LANDSCAPE PLAN
PRO CHOICE PLUMBING
MARION COUNTY
FLORIDA

IRRIGATION PLAN
 PRO CHOICE PLUMBING
 MARION COUNTY
 FLORIDA

LANDSCAPE & IRRIGATION DETAILS
 PRO CHOICE PLUMBING
 MARION COUNTY
 FLORIDA

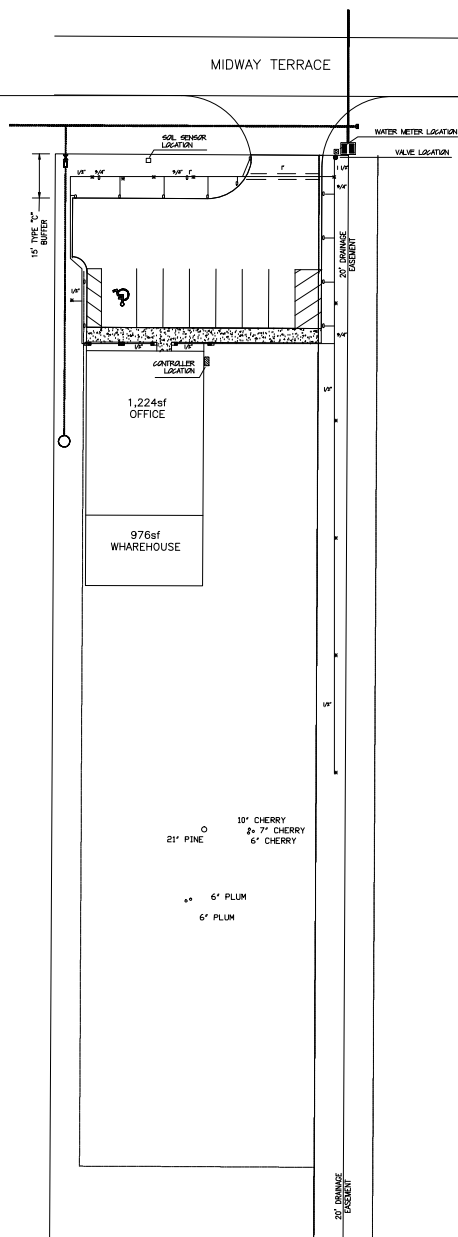
Crape myrtle does not meet intent of year round screening, majority of buffer understory trees to be evergreen species

Waiver required to use understory in parking terminus island

Will there be outdoor lighting? if so, a signed and sealed photometric plan is required

screening required for parking area this area

C type buffer required along south boundary
